Glory Textile & Apparels Ltd.

11 April 2022

Observations

Observation: Dyeing Building, Utility Building

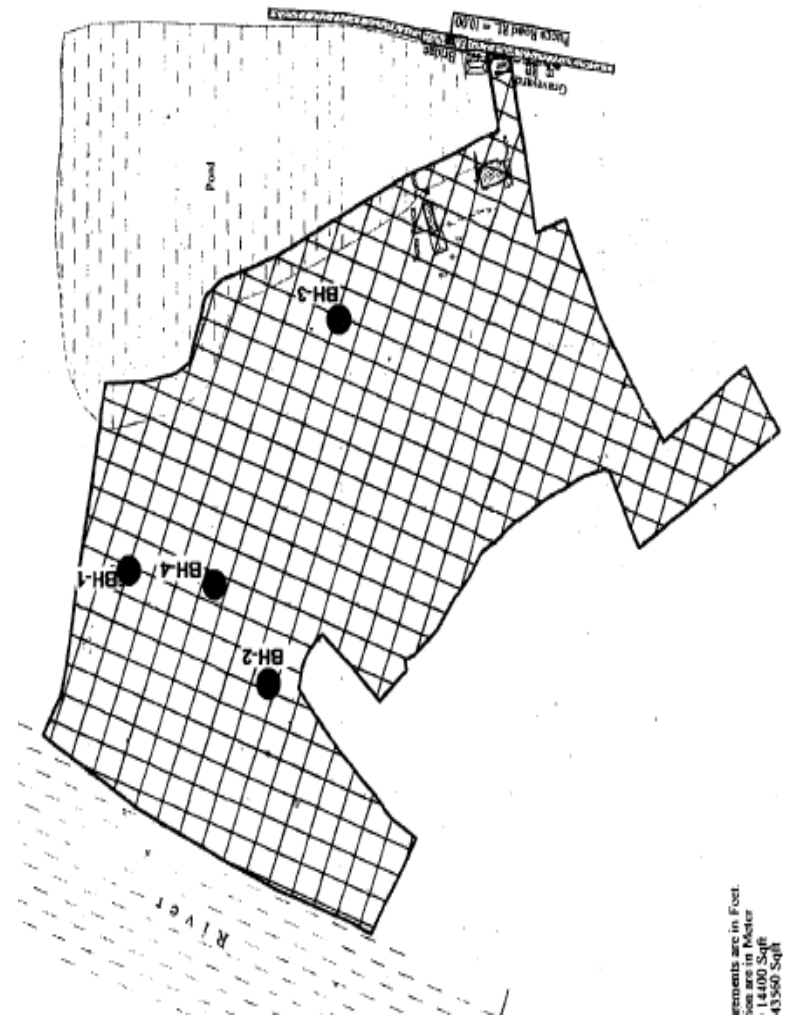
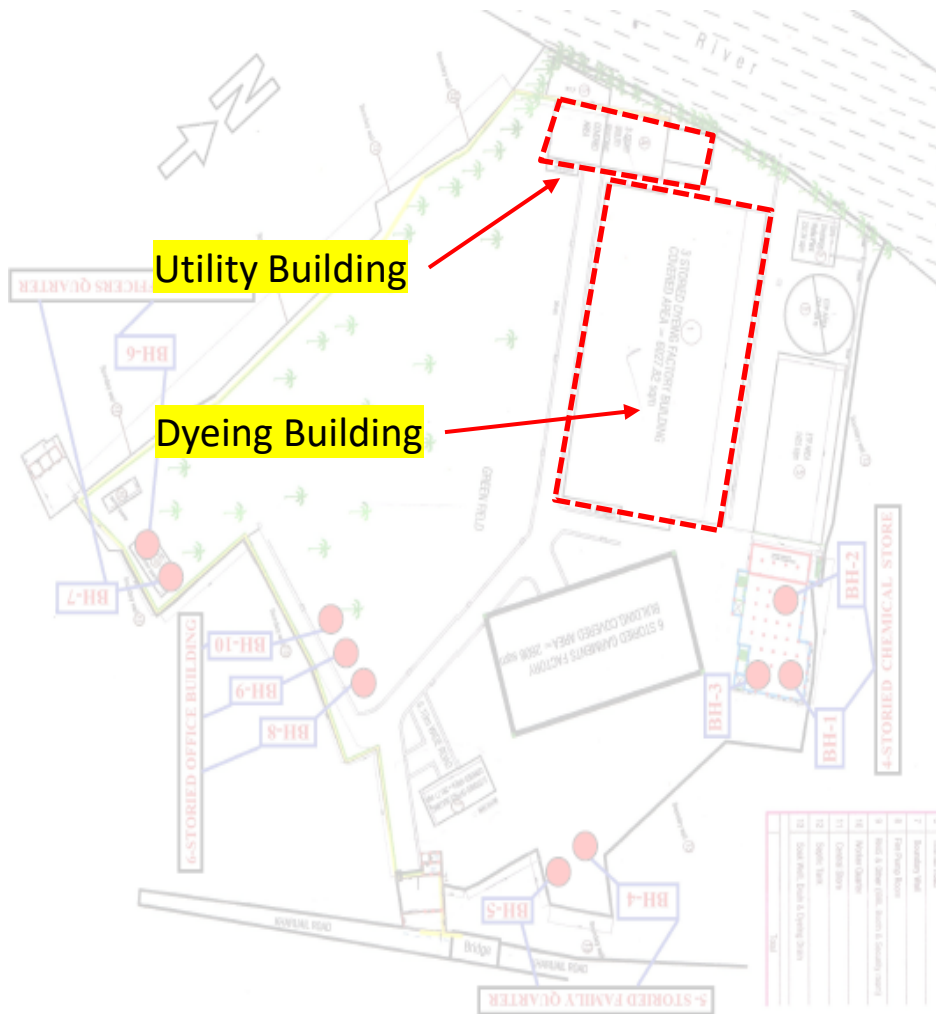
As per BNBC, every building or structure designed shall have its design documents prepared in accordance with the provision of Section 1.9.1. The design document shall include a design report, and a set of structural drawings, which shall be prepared in compliance with section 1.9.1.1 and section 1.9.1.2 of part-6, BNBC.

However, design report was not available during inspection. The building engineer is required to prepare a design report in compliance with BNBC.

Lack of structural details

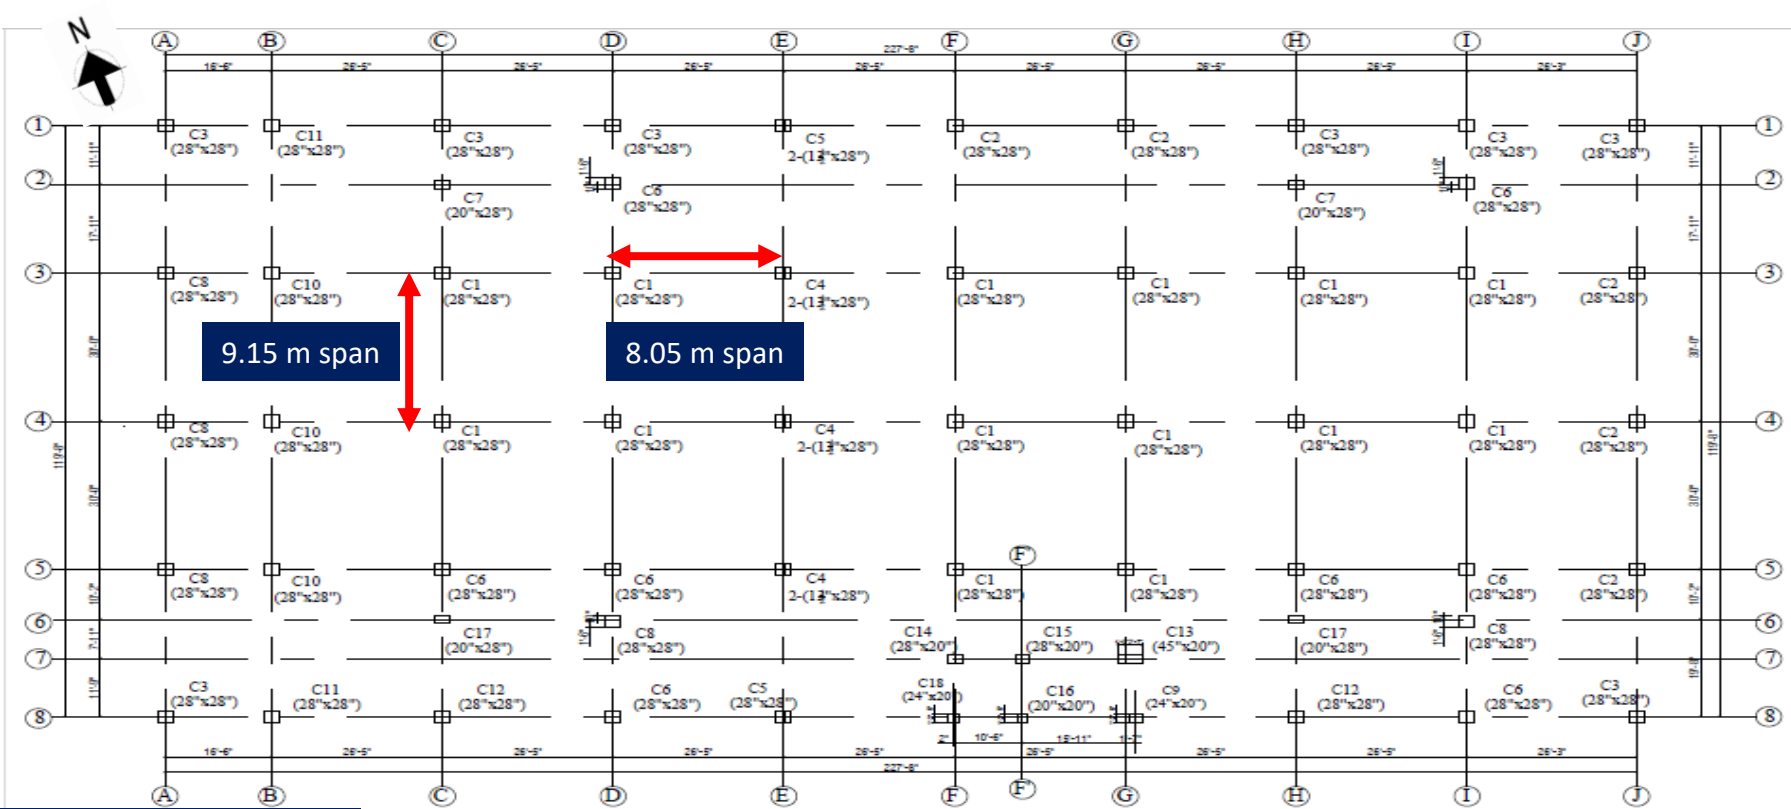
Structural details of OHWT & mezzanine floors of M-2 & M-3 are not shown in the structural drawings. The building engineer is required to survey the structure and produce accurate structural details.

Column layout plan

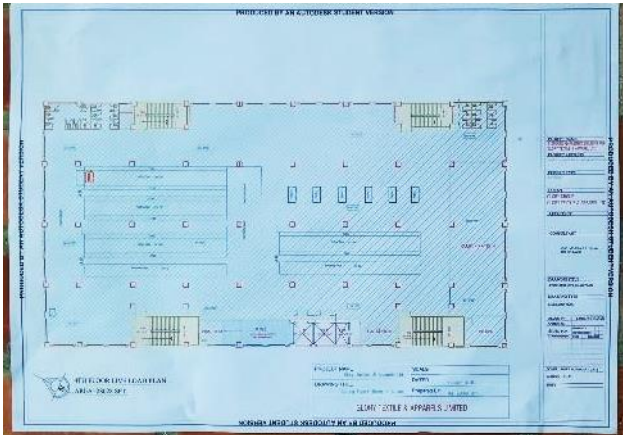
The cursory calculation indicates that columns are stressed above the normal design limit considering the prepared live load plan of 5 kPa and the concrete strength from the available cylinder test data. Building engineer is required to review design, load & column stress.

Lateral stability system of the building

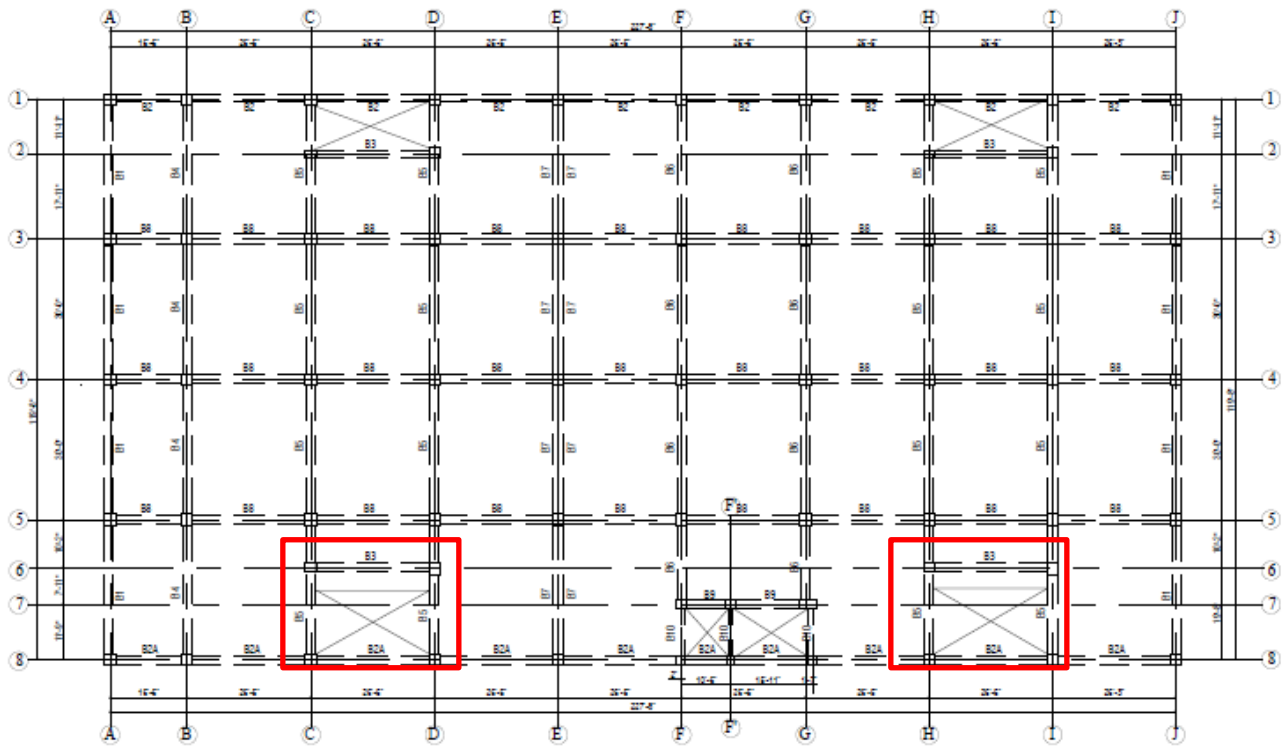
There are different structural system acting together to provide lateral stability of the building. Due to difference of stiffness in same structure, the lateral stability system need to be verified by further design check.

Dampness throughout the building

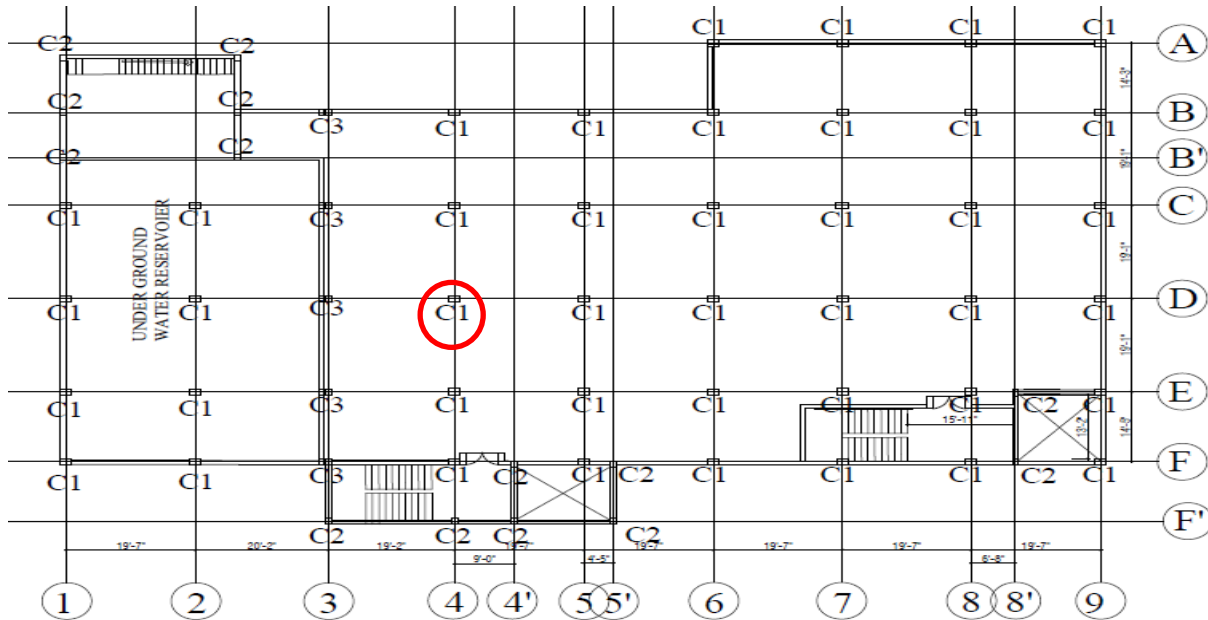
Dampness observed throughout the building. Building engineer is required to check the reason and extent of the dampness and suggest suitable repair method.
